Re: PEX2024/0002

**Background PEX2024/0002**

As you are aware this Planning Proposal application (PEX2024/0002) seeks a site-specific amendment to Warringah Local Environmental Plan 2011 (WLEP 2011) to increase the maximum height of buildings permitted on the site from 12 and 13 metres to 32 metres at the corner of Dee Why Parade and Pittwater Road, and 23 metres across the remainder of the site. It is to expressly develop the site for seniors housing, which is already a permissible use on the land, as it is zoned R3 Medium Density Residential under WLEP2011. The Planning Proposal also seeks to implement site-specific development provisions to guide a future seniors housing development on the site, for inclusion as an amendment to Warringah Development Control Plan (WDCP 2011).

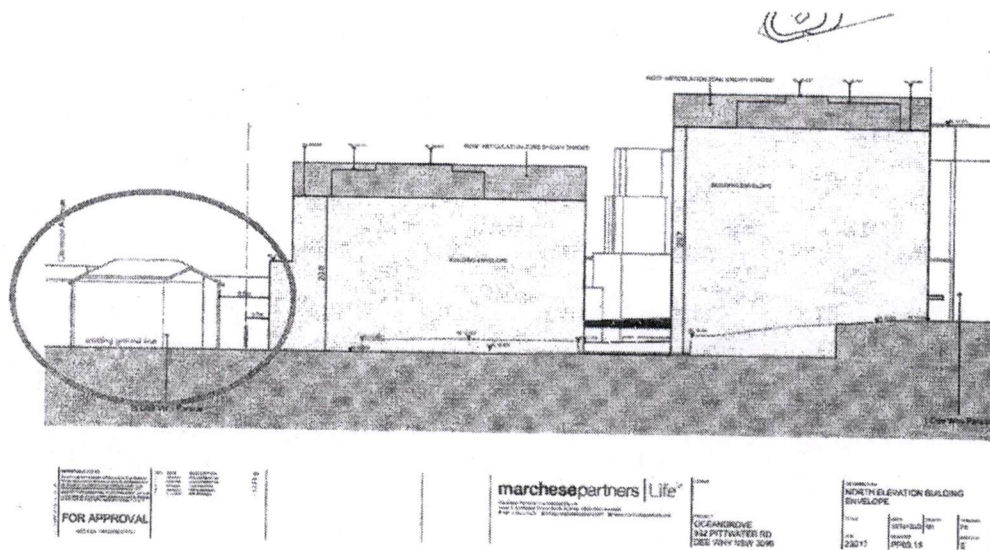
**Image above** - The information provided with this Planning Proposal identifies “possible future built form” however shows the existing building on the site. No attempt has been made to demonstrate that the potentially isolated site is able to be re developed. The site should be included in the proposed building height “uplift” to ensure uniform development controls apply.

Figure 13 Development Concept building envelope and site context

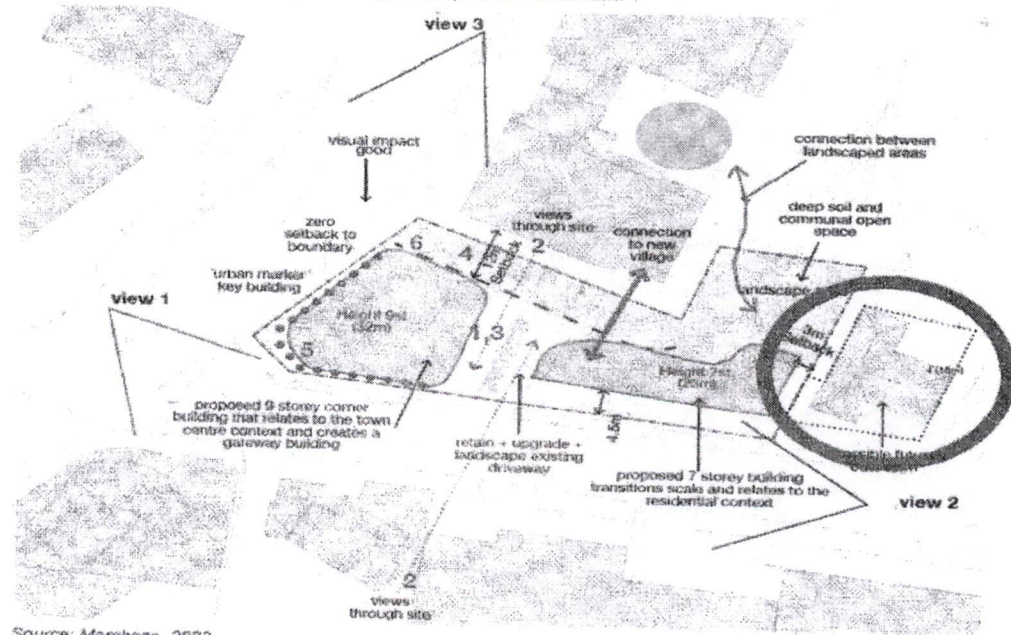
**Image above** - From the report appears to show “existing” development rather than “possible future development” there does not appear to be any substantive demonstration that the site can be developed independently.
